UNITED STATES PATENT AND TRADEMARK OFFICE

APPLICATION NO.	FILING DATE	FIRST NAMED INVENTOR	ATTORNEY DOCKET NO.	CONFIRMATION NO.
10/714,774	11/17/2003	Donald Siu	PD-200349	2413
20991	7590	09/21/2006	EXAMINER	
THE DIRECTV GROUP INC			PAYNE, DAVID C	
PATENT DOCKET ADMINISTRATION RE/R11/A109				
P O BOX 956			ART UNIT	PAPER NUMBER
EL SEGUNDO, CA 90245-0956			2613

Office Action Summary

DETAILED ACTION

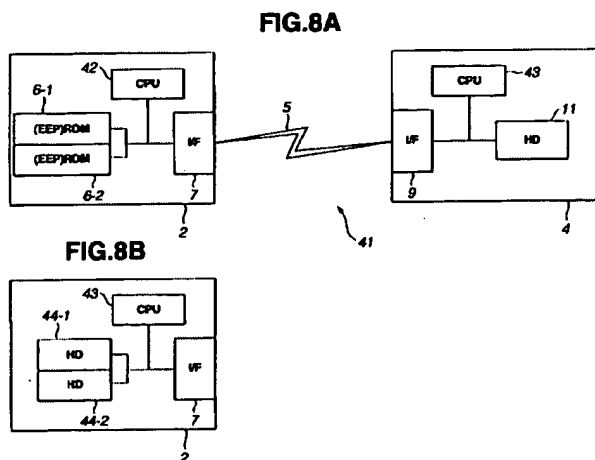
1. The drawings are objected to because drawings contain blank boxes and other shapes (Figure 1, #112, #116) and (Figure 2, #112, #116, #120), which are not widely, recognized engineering symbols. Applicant must supply a suitable legend. A proposed drawing correction or corrected drawings are required in reply to the Office action to avoid abandonment of the application. The objection to the drawings will not be held in abeyance.
